PROJECT: CHUCK E. CHEESE'S  
1371 KOOSER ROAD  
SAN JOSE, CA

## PLAN CHECK CORRECTION COVER SHEET

PLAN REVIEW CORRECTION CHECKLIST

## SAN JOSE FIRE DEPARTMENT PLAN CHECK COMMENTS

CHK. MONITOR

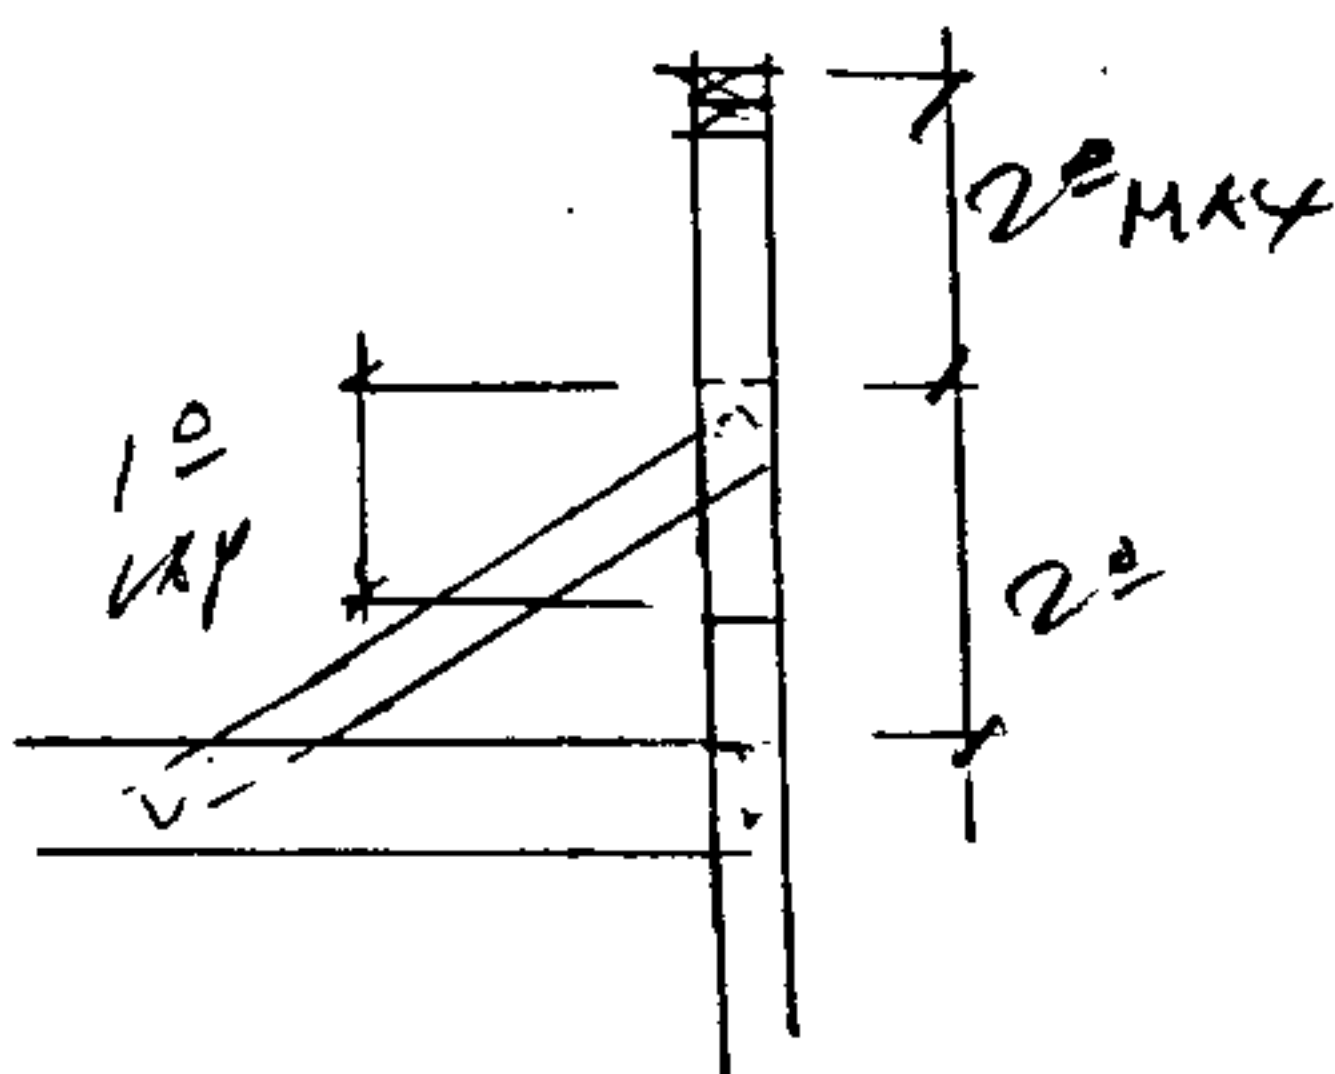
| 7    | A2      | DETAIL 02-- PROVIDE ANCHORAGE & BRACING CALCS FOR DROP HEADER                        |
| 8    | A2      | DETAIL 03-- DO NOT BRACE ANYTHING (i.e. MONITOR) FROM CEILING GRID                   |

$$d = 19.5' \text{ net} \quad UT = 300 \text{ # max} / 2 \text{ JOISTS} \\ = 175 \text{ #}$$

$$W = (15 \text{ psf} + 20 \text{ psf}) 1.33 = 46.6 \text{ #}$$

$$M = .0466 (19.5)^2 / 8 + .175 (19.5) / 4 = 3.07 \text{ #}$$

$$S = 3.07 \times 12 / 1.45 \times 1.25 = 20.3 \text{ #}^3 \quad (12) \rightarrow 2 \times 12 @ 16" \text{ O.K.}$$
